ANN ARBOR HISTORIC DISTRICT COMMISSION

Staff Report

ADDRESS: 811 Catherine Street, Application Number HDC21-257

APPLICATION: The applicant seeks HDC approval to install sashes for nine wood windows that were removed and replaced with vinyl windows without a certificate of appropriateness or building permits. The sashes are replicas of the historic windows that were removed and would replace the modern windows currently installed.

CAMPUS MANAGEMENT
811 Catherine
FIRST FLOOR

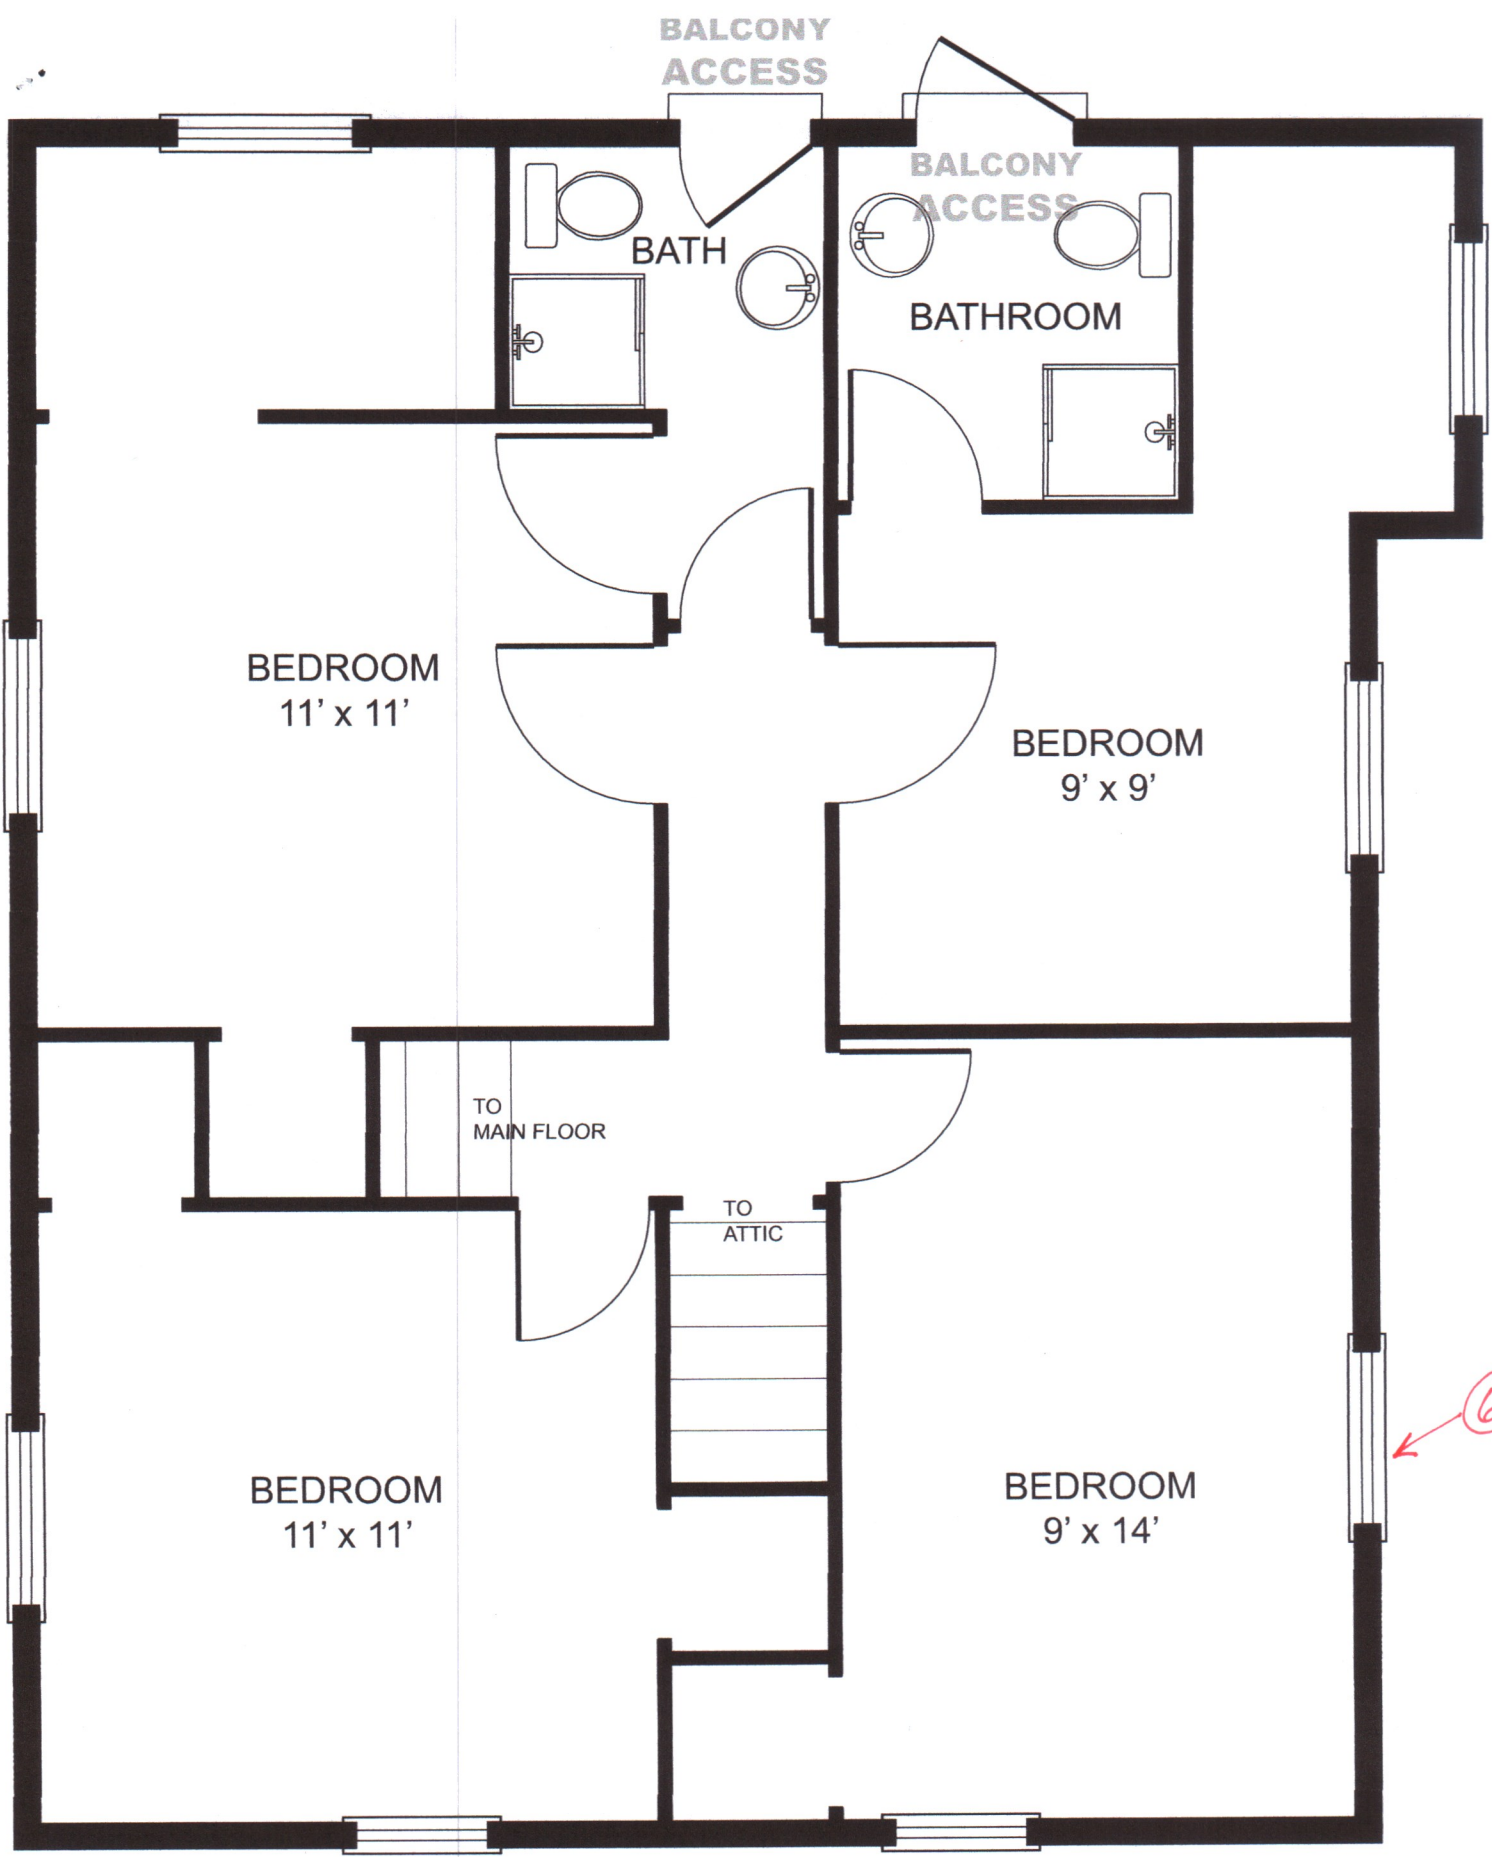
1. Material of the new windows
2. Were all the removed windows one-over-one? Double hung or single?
3. Provide a profile drawing of a surviving window that will be used as a template for the new windows.
4. Was the exterior trim replaced with the windows? If yes, what was the previous and existing material?
5. Was the small window next to the front door originally operable, or fixed?
6. Confirm that the front window on the first floor will return to one window in the existing opening instead of two.

2) all of the windows are double-hung windows with one exception being the single stationary porch window. As far I could tell, this window was originally stationary and not a functioning window. The opening is too small to be reasonably operational.

6) yes front window is returning to one large window, likely a 12 over 1 window.

811 Catherine - 2nd Floor

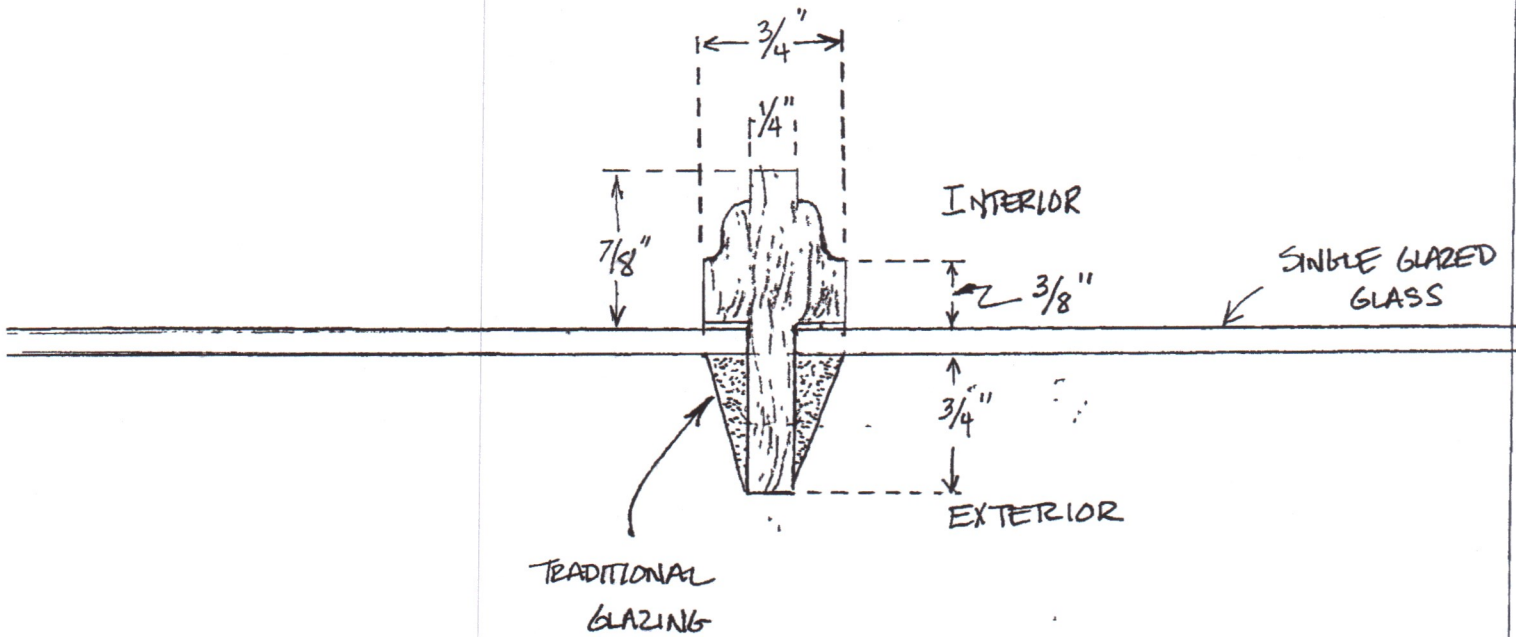
+ 2 front facing attic windows
 (8) (9)

3) we have not removed an attic window for profile reproduction. My original plan was to use the same profile bits used on the N. Ingalls windows which are very close if not exactly the same. Please know that if an exact reproduction is required, the attic window will need to be sacrificed to acquire a slice of the profile to have a custom set of bits made. This means an additional window will need to be produced. The lead time on having a custom set of bits made is 3-4 months. There will also be an additional charge of \$600-\$800 to have the bits made.
